BTeV IP Review

December 18, 2003

A review of the BTeV Interaction Point design was held on October 7, 2003. The Review committee consisted of Terry Anderson, Alexei Burov (absent), Bruce Hanna, John Johnstone, Mike Martens, Mike McGee, Nikolai Mokhov, King-Yuen Ng, Rob Roser, and Mike Syphers (chair). The presentations were well prepared and very enlightening to the reviewers, most of whom were not familiar with the BTeV project. The main issues presented and discussed during the review were: (a) vacuum, (b) impedance, (c) aperture and operations, and (d) radiation environment. Below we present, for each issue, bullets from the Review Close-out presented by Syphers, followed in each case by subsequent comments and questions from the other reviewers. (All reviewers responded with comments; extensive comments received are presented and duplications avoided where possible.) Also included are recent responses to some of the more outstanding issues, as compiled by Peter Garbincius (shown in **bold** type). The Charge to the Committee can be found at the end of the document.

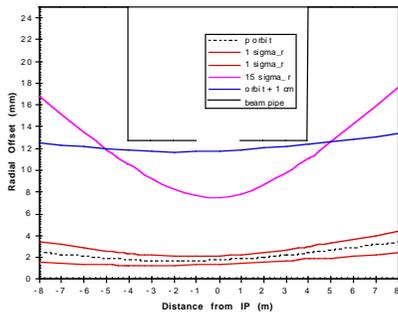
At injection the nearest approach to the aperture limits occur at the D/S end of the 1" pipe. With Yuri's preferred "5-star" helix solution the "orbit+1cm" case narrowly clears the beam pipe wall.

Horizontal Injection Clearance @ C0 Collins Straight

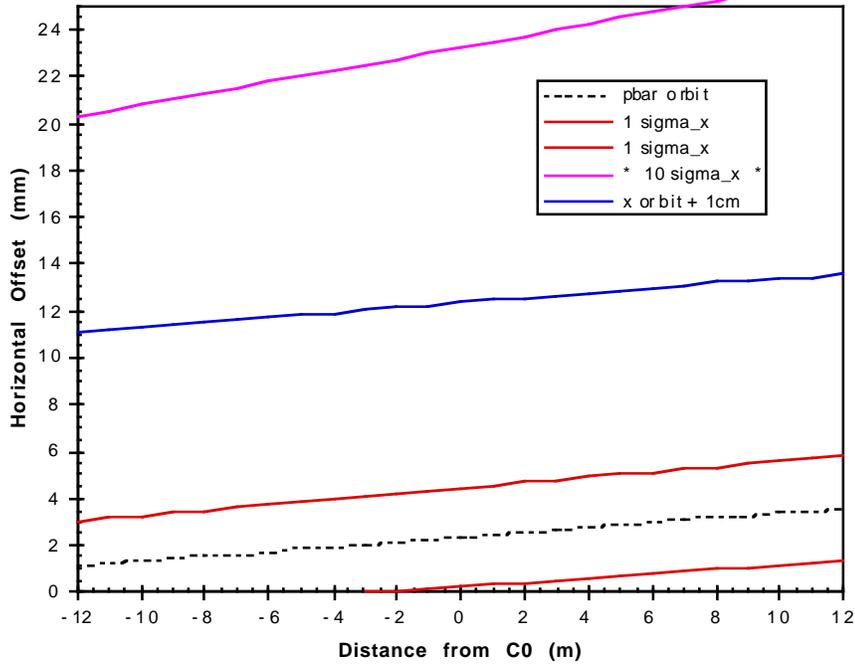
During injection, with Collins optics, the 2" pipe accepts an aperture criteria of 8-9 sigma. The "orbit+1cm" envelope fits comfortably within the pipe, with clearance > 8 mm everywhere in both planes. Horizontally, the "x-orbit+10-sigma-x" fits as far as 8 m D/S of the IP. This should be sufficient and, without the compensating B2 at this spot, it may be that the 2" pipe could become a standard 3". (Pictures of the calculated injection vertical & horizontal apertures are attached below).
